UNITED STATES PATENT AND TRADEMARK OFFICE

APPLICATION NO.	FILING DATE	FIRST NAMED INVENTOR	ATTORNEY DOCKET NO.	CONFIRMATION NO.
10/789,357	02/27/2004	John Popovich	PERMLT.019C1	5148
20995	7590	04/13/2005	EXAMINER	
KNOBBE MARTENS OLSON & BEAR LLP			TSO, LAURA K	
2040 MAIN STREET			ART UNIT	
FOURTEENTH FLOOR			PAPER NUMBER	
IRVINE, CA 92614			2875

Office Action Summary	Application No. 10/789,357	Applicant(s) POPOVICH ET AL.	
	Examiner laura tso	Art Unit 2875

FIG. 16

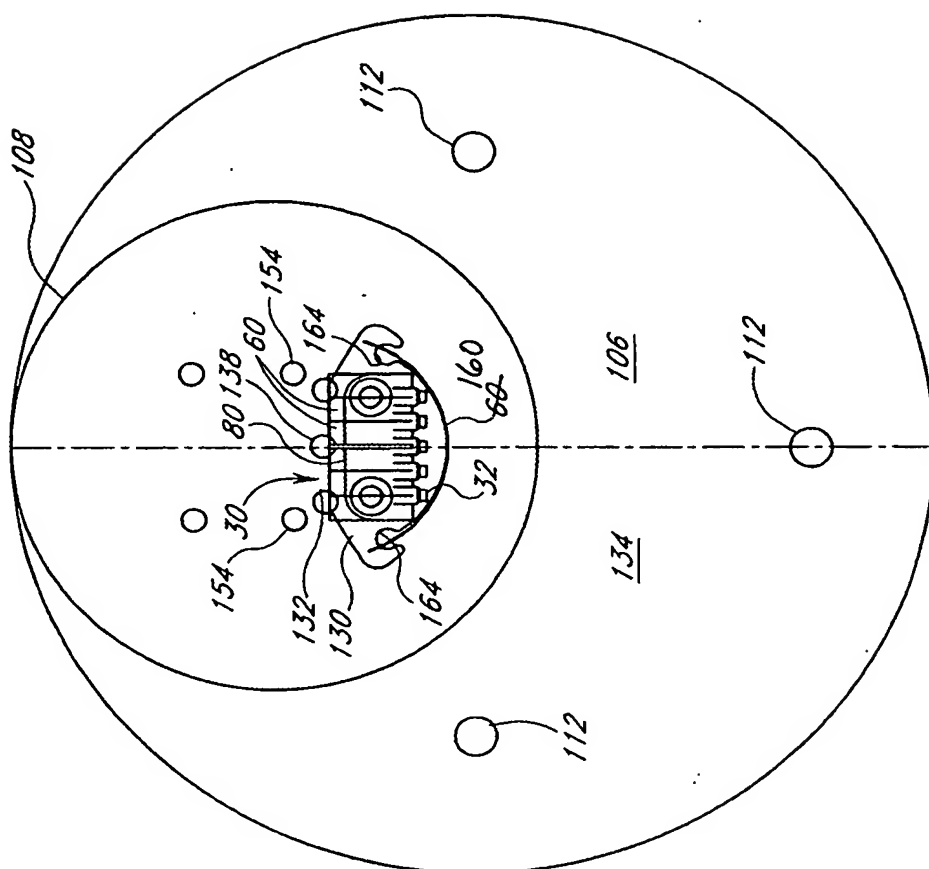
The drawings are objected to because in figure 16, applicant should change "60" to --160--. (note attachment) Corrected drawing sheets in compliance with 37 CFR 1.121(d) are required in reply to the Office action to avoid abandonment of the application. Any amended replacement drawing sheet should include all of the figures appearing on the immediate prior version of the sheet, even if only one figure is being amended. The figure or figure number of an amended drawing should not be labeled as "amended." If a drawing figure is to be canceled, the appropriate figure must be removed from the replacement sheet, and where necessary, the remaining figures must be renumbered and appropriate changes made to the brief description of the several views of the drawings for consistency. Additional replacement sheets may be necessary to show the renumbering of the remaining figures. Each drawing sheet submitted after the filing date of an application must be labeled in the top margin as either "Replacement Sheet" or "New Sheet" pursuant to 37 CFR 1.121(d). If the changes are not accepted by the examiner, the applicant will be notified and informed of any required corrective action in the next Office action. The objection to the drawings will not be held in abeyance.
